DRAFT Proposal for Supplement 2 to UN Regulation No. 151 (Blind Spot Information Systems (BSIS))

The text reproduced below was prepared by the experts from the European Commission and OICA to modify the scope of the Regulation along with appropriate requirements. The informal document is based on ECE/TRANS/GRSG/2020/7. The modifications to the current text of the UN Regulations are marked in bold for new or strikethrough for deleted characters. The modifications to the document GRSG/2020/7 are marked in yellow.

M2/N2 vehicle trajectory on 2 lanes per road entering 1 lane road

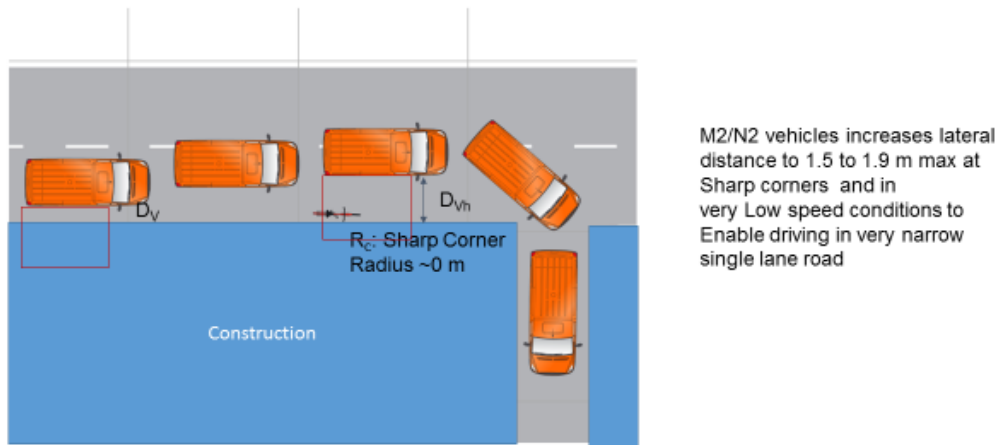
"6.5.11. Vehicles of categories N₂ with a technically permissible maximum mass not exceeding 8 tonnes and M₂ are deemed to meet the requirements of paragraph 6.5. if the Blind Spot Information signal has been activated when the bicycle target is ~~moved forward, rearward or transverse~~ moving forward as specified in paragraph 5.3.1.4.1. and entering a zone on the nearside of the moving vehicle ~~into a zone adjacent to the moving or stationary vehicle~~. In such case, the specification of the relevant zone and the activation of the information signal shall be in accordance with the manufacturer's specifications. These specifications shall however cover both the entry from the front and from the rear of the manufacturer defined zone."

- (1) Paragraph 5.3.1 : The vehicle trajectory for smaller N₂/M₂ is not using a further left turn than 2 m, therefore with the 3 m coverage the cyclists remains covers.
